Decision Notice
& Finding of No Significant Impact
Grazing Authorization
and
Allotment Management Plan
Seibold, Crittenden, Kunde and Papago Allotments

USDA Forest Service
Sierra Vista Ranger District, Coronado National Forest
Santa Cruz County, Arizona

AGENCY RESPONSE TO COMMENTS
ENVIRONMENTAL ASSESSMENT
SEIBOLD, CRITTENDEN, KUNDE AND PAPAGO ALLOTMENTS
June 16, 2003

High Density Habitat
Allotment Boundaries

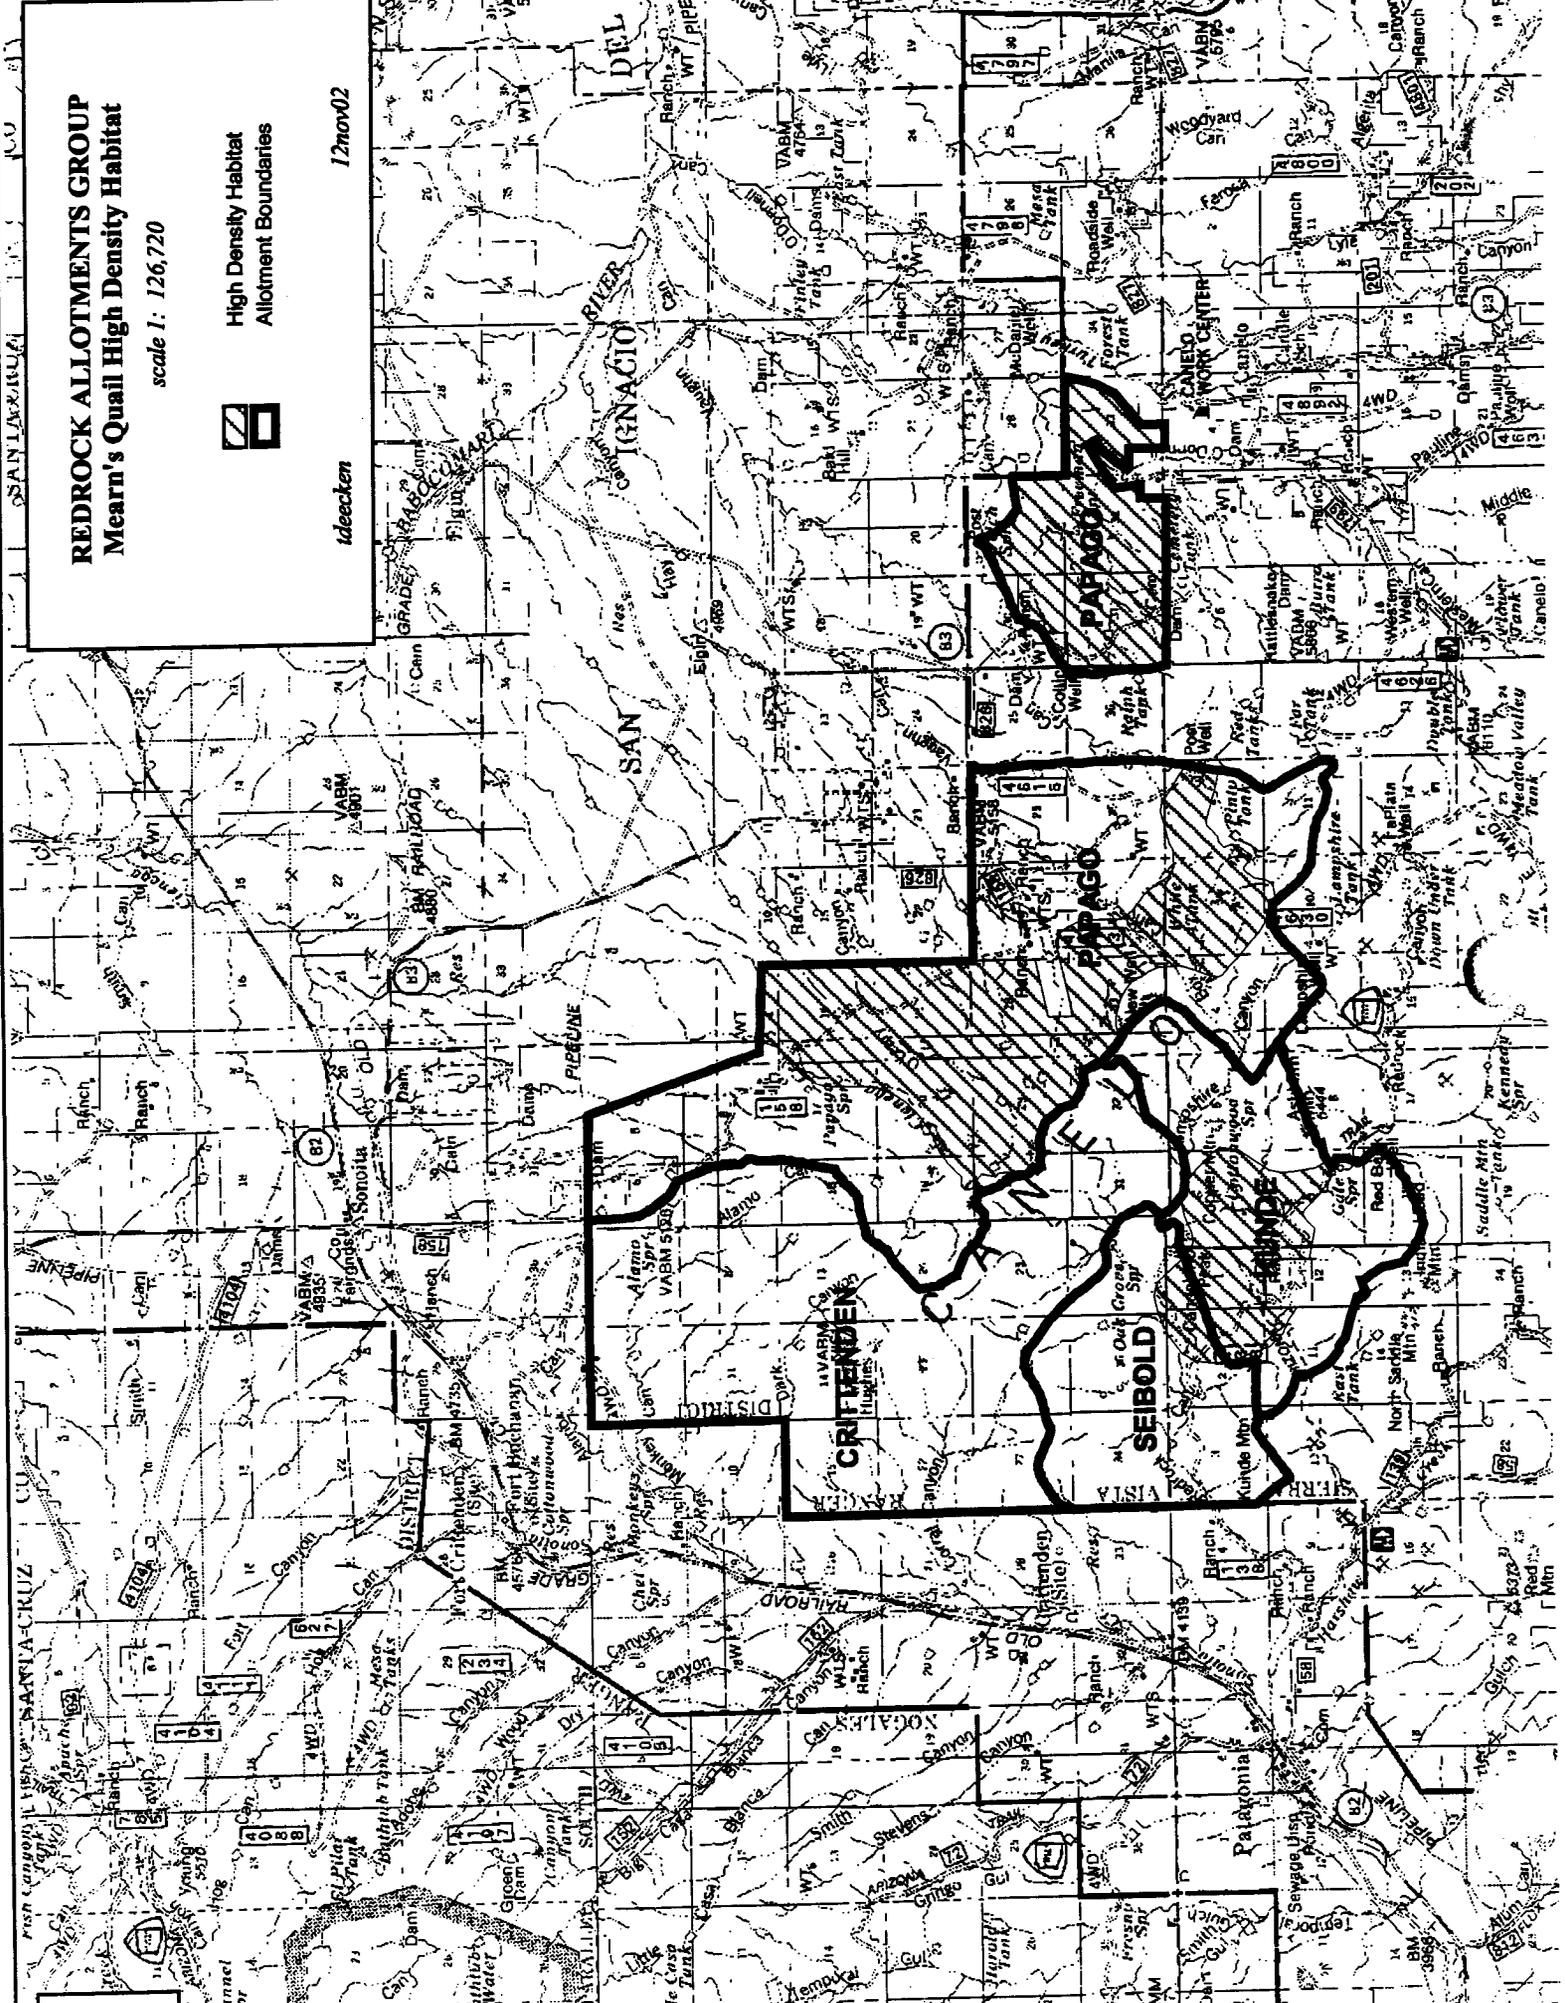
Comment 3-1: The EA states on p. 9 and 10 of the Proposed Action, under each allotment heading, that Mearns' quail key areas on Map 9. We do not have Map 9, Sierra Vista district does not have Map 9, and as we discussed on the telephone on 2 June 2003, there is not a list of designated Means' quail key areas that the public could identify.

Comment 3-2: The EA states on p.42 under Environmental Effects that Mearns' quail "key habitat areas" have been identified and are on Map 7. We believe this is a typographical error and should say Map 9. However, Mearns' quail key areas have not been defined-and there is no Map 9.

Response 3-1: Map 9 was inadvertently left out of the EA, but is included in the project record (Doc 113) and is attached to this response. We apologize for the oversight.

Response 3-2: You are correct; the reference should be to Map 9, which is attached. The reference should have been to "Mearns' quail high density habitat" rather than key areas, since these have not yet been identified. Also see Response 3-3, below.
